PCN# 20230206000.1

**Qualification of additional Fab site (RFAB) and Assembly site (CDAT) options for
select LBC7 devices
Change Notification / Sample Request**

Date: February 06, 2023
To: PREMIER FARNELL PCN

Sample product shipping label (not actual product label)

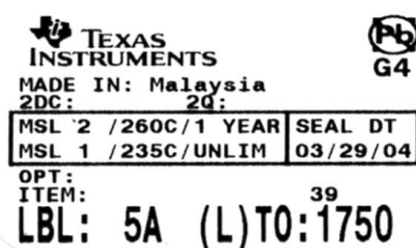
Changes to product identification resulting from this PCN:**Fab Site Information:**

Chip Site	Chip Site Origin Code (20L)	Chip Site Country Code (21L)	Chip Site City
MIHO8	MH8	JPN	Ibaraki
RFAB	RFB	USA	Richardson

Assembly Site Information:

Assembly Site	Assembly Site Origin (22L)	Assembly Country Code (23L)	Assembly City
UTL1	NSE	THA	Bangkok
UTL3	UT3	THA	Bangpakong
CDAT	CDA	CHN	Chengdu
